# 1966 Corvette: Service Bulletin: Automatic Choke Malfunction

**Source:** Chevrolet Technical Service Bulletin

**Bulletin No:** TSB #66-6, DR #66-6

**Date:** November 18, 1965

FIG. I - CHOKE THERMOSTAT ASSEMBLY - 283 V-8

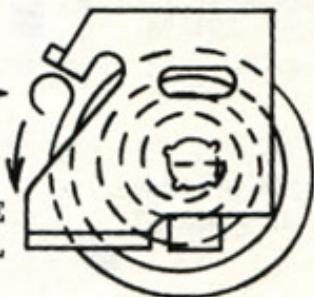
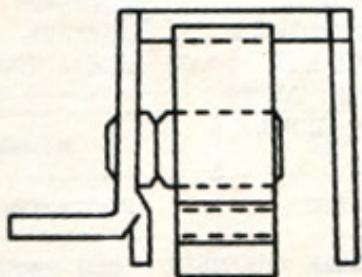
It should be noted that an important difference exists between the 327" (275 h.p.) engine choke operation and the remaining V-8 engines. That is, the direction of the thermostat operation between the two units is reversed. On the 327" (275 h.p.) application, the eye of the thermostat coil and the corresponding choke rod travels from a down position for closed choke relaxing upward for open choke. On the remaining V-8 engines (except 283 4

NOTE: Choke thermostat assemblies, although similar in appearance, are not interchangeable. Check bracket design as shown in Figures I, II and III and the coil spring identification number shown on chart (Number stamped in coil, not number in ink). Choke coil springs are indexed to bracket and must not be interchanged or repositioned.

ENGINE	283 2 BBL.	327 (275 HP)		
CARBURETOR	Rochester	Carter	Holley	Rochester
CHOKE ROD	3840907	3881867	3887112	3881868
Carb End	4.70"	3.75"	2.70"	2.68"
Thermostat End				
THERMOSTAT ASSEMBLY COIL IDENT. NO.	3840909 Refer to Fig I "1262"	3887110 Refer to Fig. II "7108"	3887109 Refer to Figure II "9938"	
ENGINE	327 (300 HP)		327 (350 HP)	
CARBURETOR	Holley		Holley	
CHOKE ROD	3881866		3881888	
Carburetor End	2.80"			
Thermostat End				
THERMOSTAT ASSEMBLY COIL IDENT. NO.	3869926 Refer to Fig. III "9938"		Note 1 3887148 Refer to Fig. III "7149"

FIG. III - CHOKE THERMOSTAT ASSEMBLY - V-8 exc. 283 & 327 (275 HP)

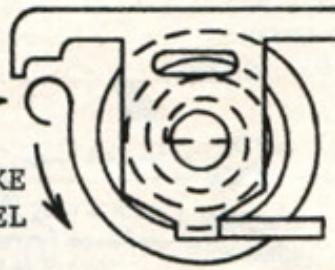
bbl. with integral choke), the thermostat operation is just the opposite, it travels from an up position from closed choke downward for open choke.

ENGINE	396 (325 HP AND 360 HP) 427 (390 HP)		396 (375 HP) 427 (425 HP)
CARBURETOR	Holley	Rochester	Holley
CHOKE ROD	3886027	3874890	3885070
Carburetor End			
THERMOSTAT ASSEMBLY COIL IDENT. NO.	3869926 Refer to Fig. III "9938"	Note 1 3887148 Refer to Fig. III "7149"
